DEVIATION REQUEST AND DECISION FORM

Project Name : Grandwood Ranch
Schedule No.(s) : 6119000003
Legal Description : S2N2, EX PT TO HIGBY RD CONV BY REC# 205092691 W/MR SEC 19-11-66

DEV #5

PCD File No. SP-195

Deviation Exhibit 2
Length of Cul-de-Sac
 Grandwood Ranch (LSC# 185020)

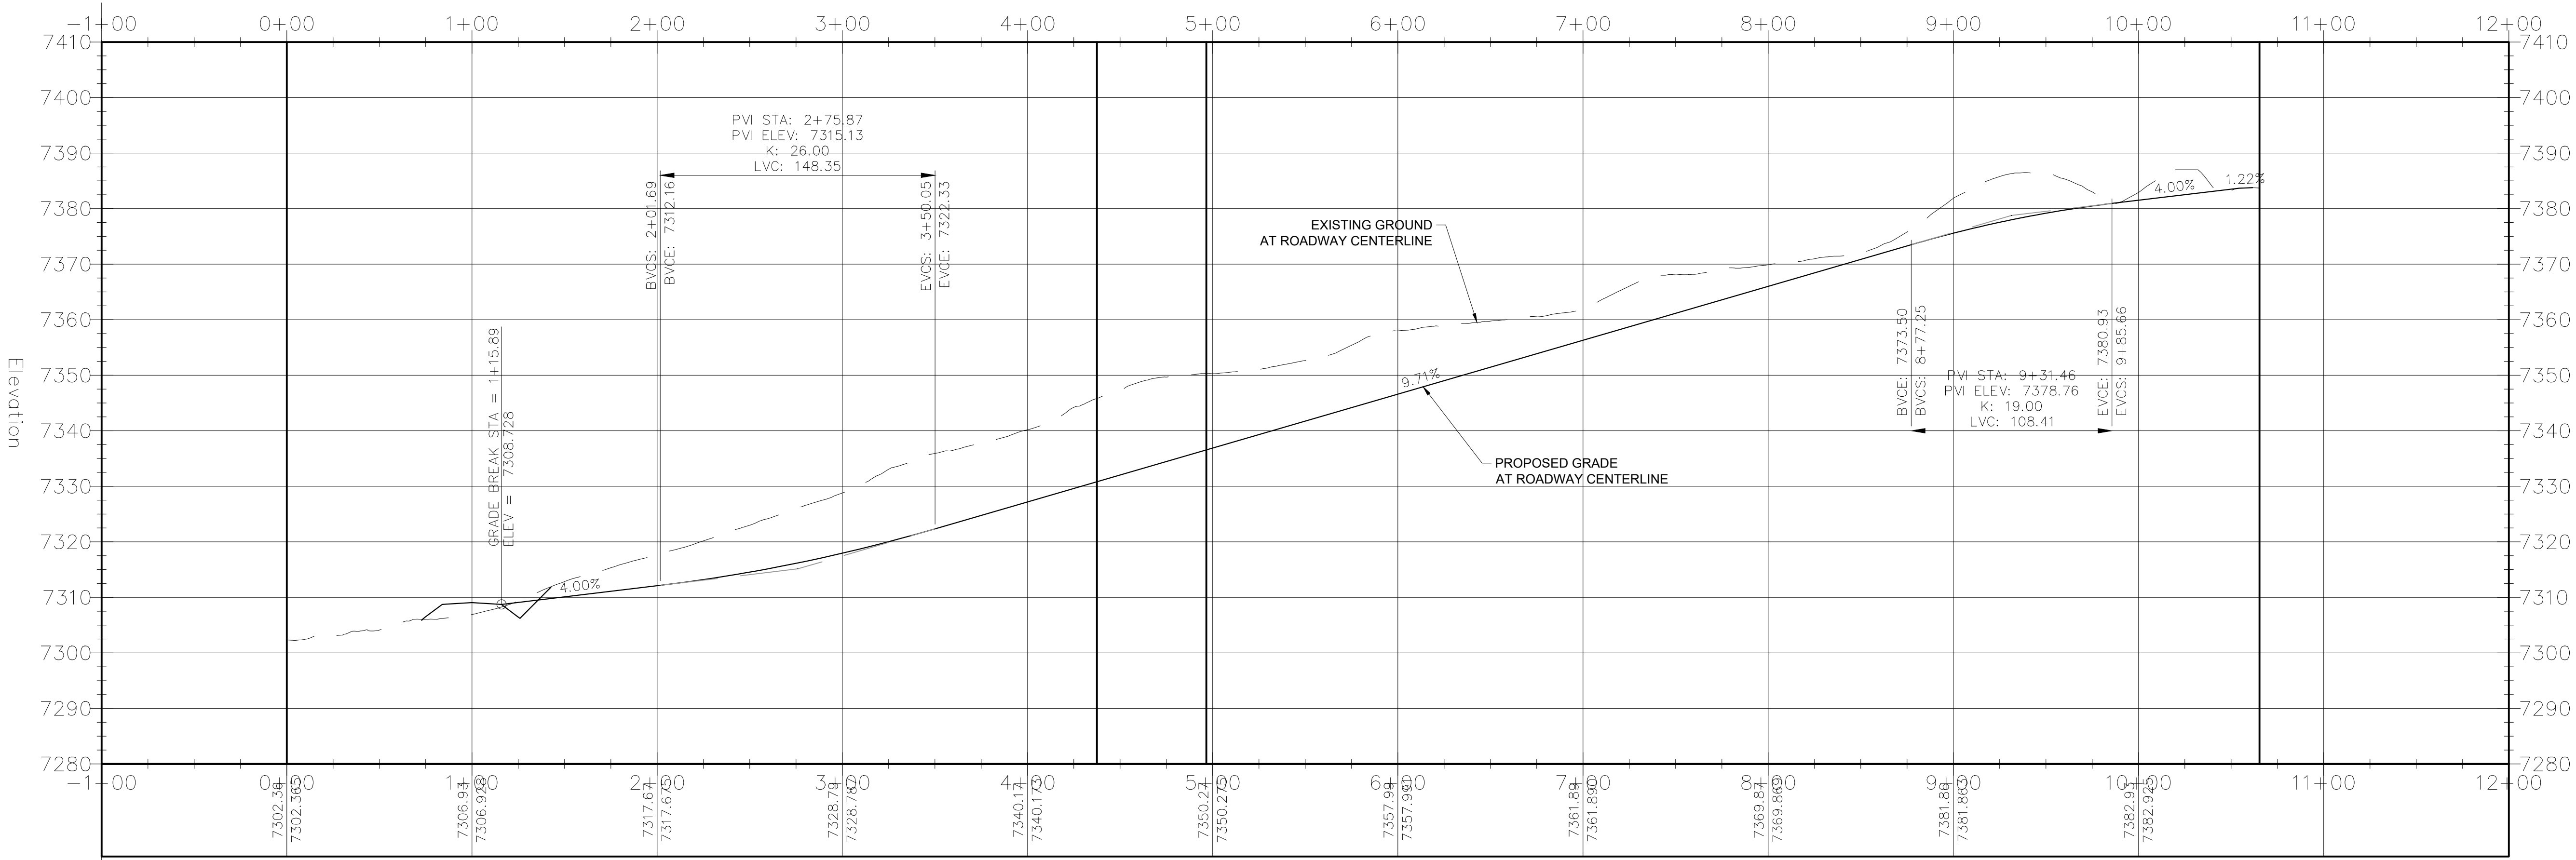
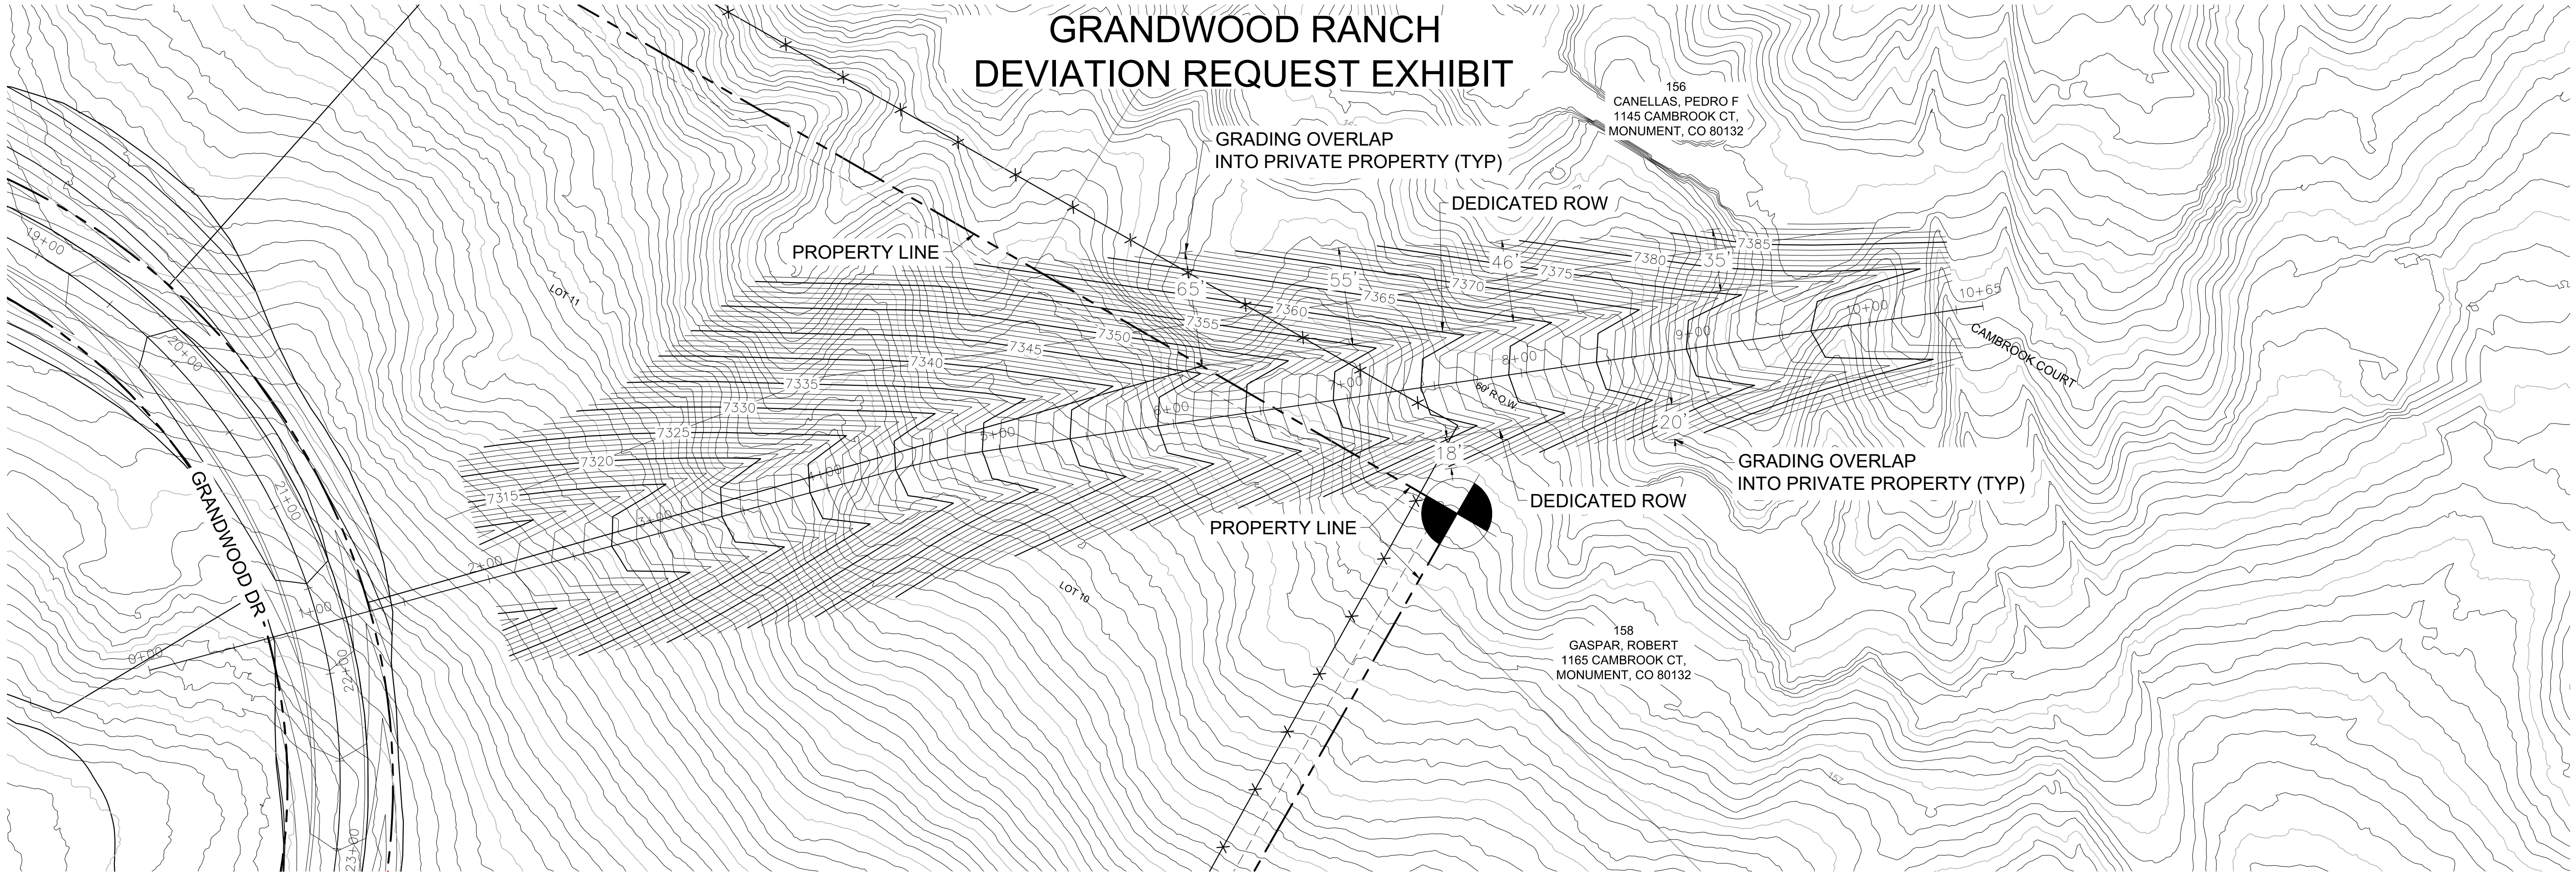
Cul-de-sacs shall have a maximum length of 1,600 feet for rural condition. The request is to allow a non-through street, Grandwood Drive, with a length of 2,542 feet. Please refer to Deviation 2 Exhibit. An emergency-use only connection is proposed from the end of the cul-de-sac to Higby Road, as shown in the exhibit.

- The cul-de-sac termination on the east access (located 2,542 feet from Higby Road) would exceed the ECM standard of 1,600 feet by 942 feet.
- The proposed cul-de-sac is shown in the attached exhibit Figure 2 (site plan).
- An emergency-use only connection is proposed from the end of the cul-de-sac to Higby Road, as shown in the attached deviation exhibit.
- A knuckle has been provided along Grandwood Drive for intermediate vehicle use. This will allow passenger, maintenance and emergency vehicles make use of without having to travel to full cul-de-sac length.
- Twenty-one 2.5-acre lots would access this proposed cul-de-sac roadway. Five of these lots would also have frontage along Higby Road, although the homesite driveway accesses would be taken from the proposed internal road.
- Please refer to the attached letter from the fire district.

- Sensitive natural features within the site to the west that are required of preservation.
- Limited connectivity to public roads. Although there is an established public right-of-way northeast to Cambrook Ct., a road connection to Cambrook Ct. via this ROW in Bent Tree would result in excessive slopes into private property. See attached Exhibit by Matrix Design Group showing extensive slope work that would be required.

- Twenty-one total lots would access the cul-de-sac. The Land Development Code indicates, "A corner lot is not counted in the maximum number of lots on a dead-end road when the fire department determines that adequate emergency access is provided to the corner lot by an alternative road." Five of these lots would also have frontage along Higby Road, although the homesite driveway access would be taken from the proposed internal road.

This request has been determined to have met the criteria for approval. A deviation from Section 2.3.4B, 2.3.7C of the ECM is hereby granted based on the justification provided.

The proposed emergency access road shall be placed in a tract, owned and maintained by the owners association. The access road shall be constructed using a gravel surface course in conformance with the ECM for gravel roadways (ECM table D-7). The width will be determined and shown on the preliminary plan.
